**100 Durgin Lane
TAC Submission Documents
for August 6, 2024 TAC meeting**

Re: **Request for Site Plan Review & Conditional Use Permits Review
100 Durgin Lane – Proposed Redevelopment**

100 Durgin Lane - Site Plan Review - TAC COMMENTS (6/28/2024) RESPONSE

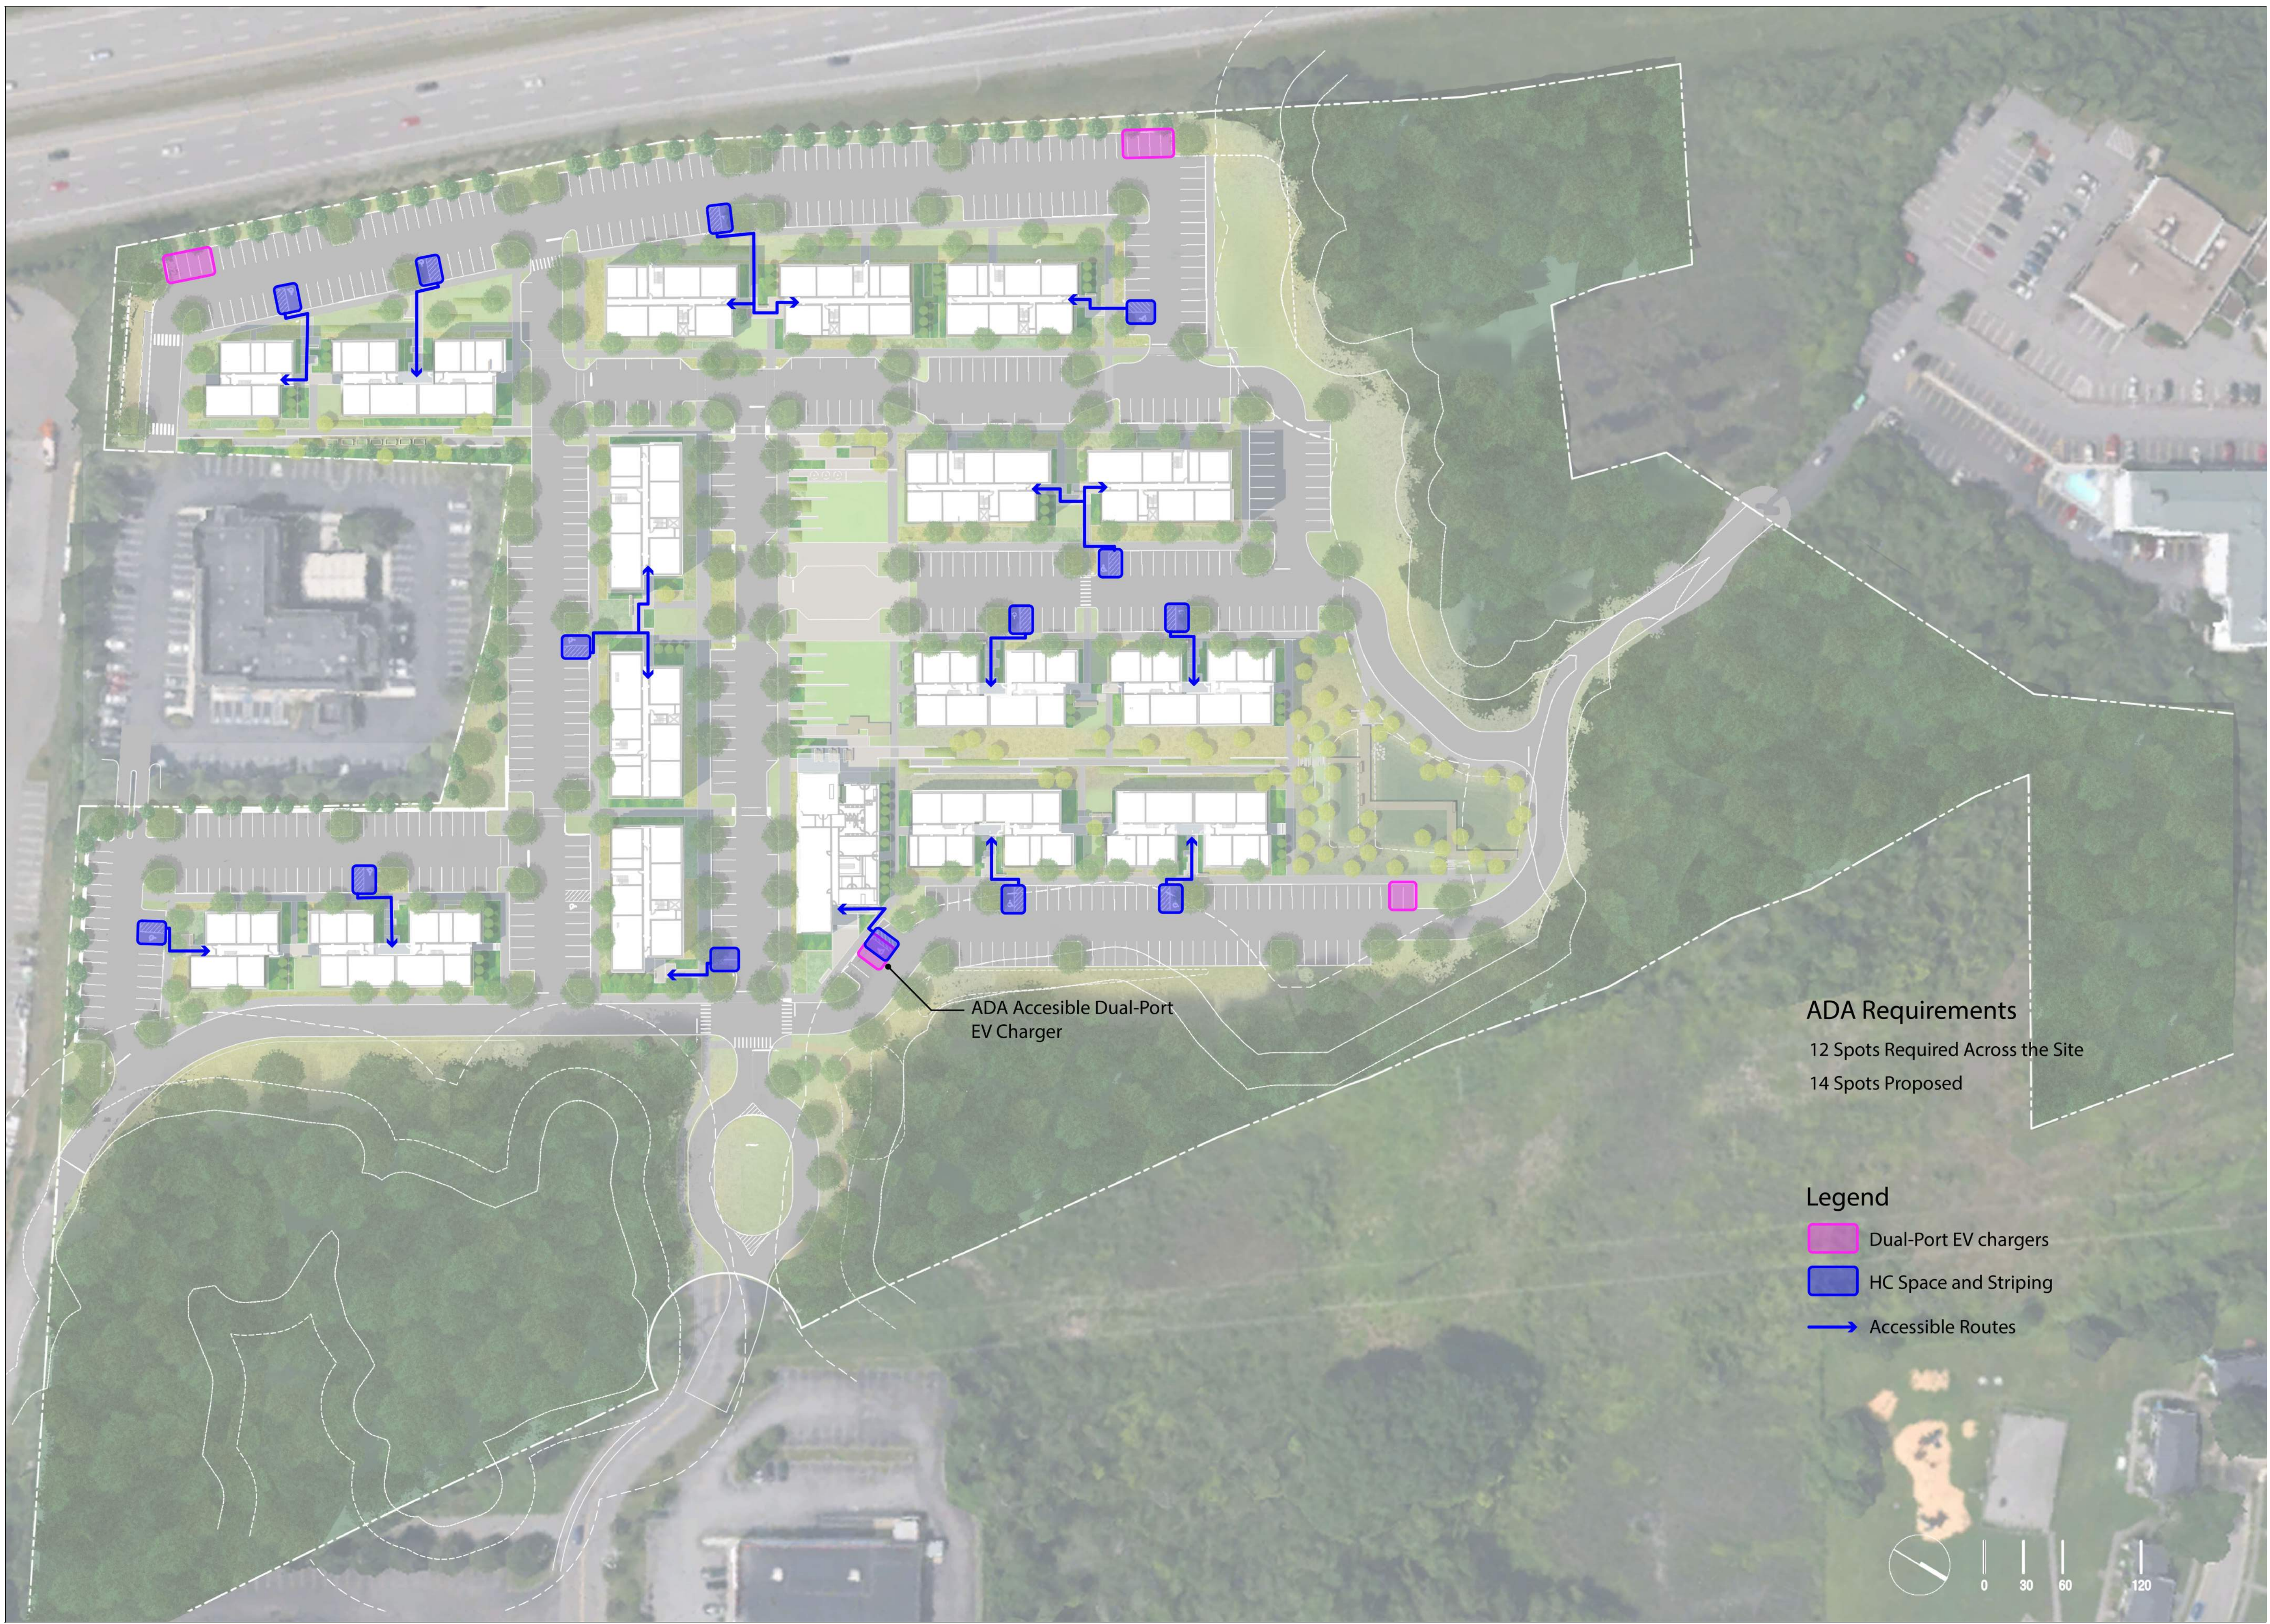
18	ADA parking spaces and walkways do not appear to be in compliance.	See sheet L-401 which highlights ADA parking spaces and direct, accessible routes from HC spots to building entrance.	L4-01
19	Include a turnaround at the end of Durgin Lane.	A turnaround is now proposed at the end of Durgin Lane in coordination with the general requirements received from DPW.	C-302
20	Reconstruct sidewalk on Durgin Lane from site to Woodbury Ave.	The Applicant will continue to further review with City Staff.	
21	"Tee" off the proposed parking lot intersection for Building 1 to the access road.	The proposed parking lot intersection for Building #1 now "tees" off the primary access road.	C-300, C-302
